Access Compliance Report

Public Rights-of-Way

Intersection ID: 28397	Main Street: COMMONS_CROSSING_DR	Cross Street: WADE_ARDREY_RD	Location: NW
ADA ID: 99D964147DAE	Ramp Type: Combination1	Initial Pass/Fail: Fail	Overall Compliance: No
		Severity Score: 10

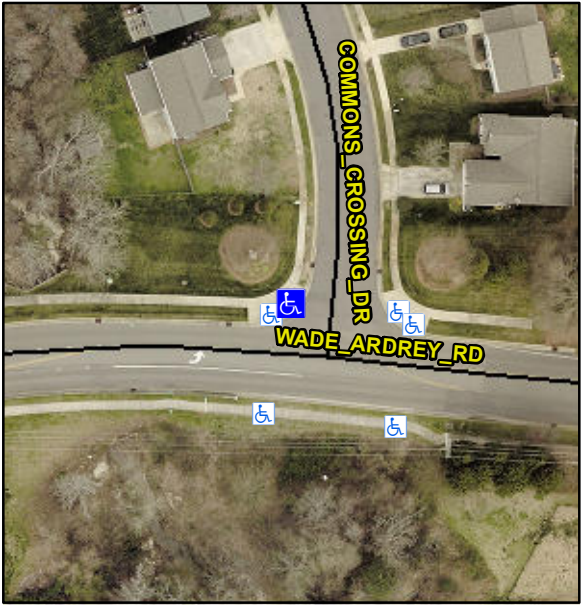
Codes/Mitigation Info/Possible Solution			Field Measurements/Component Compliance			
	Possible Solutions:		Compliance	Description	Data	Compliance
	Remove & Replace Entire Ramp.		Description		Data	Description
			N/A	Ramp Length LT (in)	36.0	N/A
			Yes	Ramp Width LT (in)	60.0	Yes
			Yes	Ramp Slope LT (%)	4.0	Yes
			No	Ramp XSlope LT (%)	2.7	No
			N/A	Ramp Length (in)	68.5	Yes
			No	Ramp Width (in)	44.0	No
			N/A	Flare Type LT	N/A	N/A
			N/A	Flare Slope LT (%)	N/A	N/A
Surveyor Notes: LT RP < 5% PROW/ADA: Not Found, R304.5.1, R304.5.3			N/A	Flare Traversable LT?	N/A	N/A
			N/A	Landing Length (in)	N/A	N/A
			N/A	Landing Width (in)	N/A	N/A
			N/A	Landing Slope (%)	N/A	N/A
			N/A	Landing X Slope (%)	N/A	N/A
			N/A	Landing Curb? (Y/N)	N/A	N/A
			N/A	Shared Landing?	N/A	N/A
			N/A	Gutter Ponding?	N/A	N/A
			N/A	Gutter Lip Ht (in)	N/A	N/A
			N/A	Painted X Walk1?	No	N/A
Street 1 Name Stop Condition-Street 1 Street 2 Name Stop Condition-Street 2				X Walk 1 Direction	To E
